Nota Técnica 01-F4-2023

Comité Organizador Campeonato de España de F4

Technical note 01-F4-2023

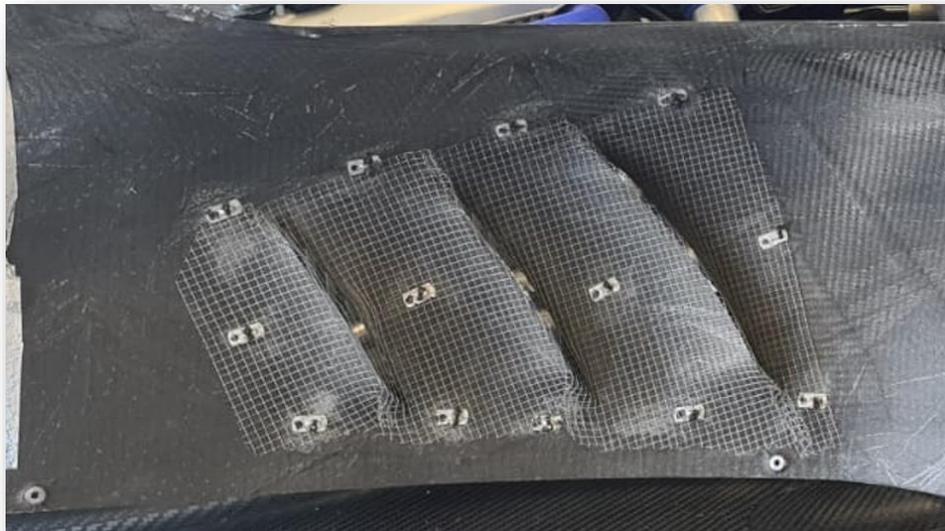
En base al Artículo 2.5.3, se autoriza la instalación de una protección de malla en la cara interior de las aberturas de refrigeración de la carrocería lateral inferior. Las aberturas mencionadas son las que se muestran en el dibujo inferior.

- La malla deberá ser de material metálico o plástico.
- Los soportes de la malla deberán estar fijados a la carrocería por medio de adhesivo.
- Las fijaciones de la malla a los soportes deberán ser desmontables.

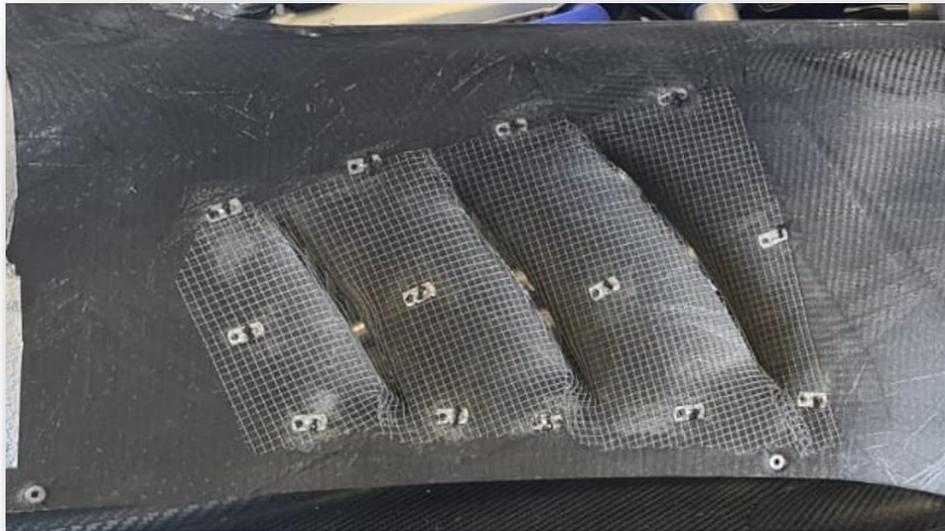
Based on Article 2.5.3, it is authorized the installation of a protective mesh in the inner face of the cooling openings of the lower side bodywork. The abovementioned openings are shown in the drawing below.

- The mesh must be made of metal or plastic material.
- The supports of the mesh must be fixed to the bodywork by adhesive.
- The fixation of the mesh to the supports must be dismantlable.
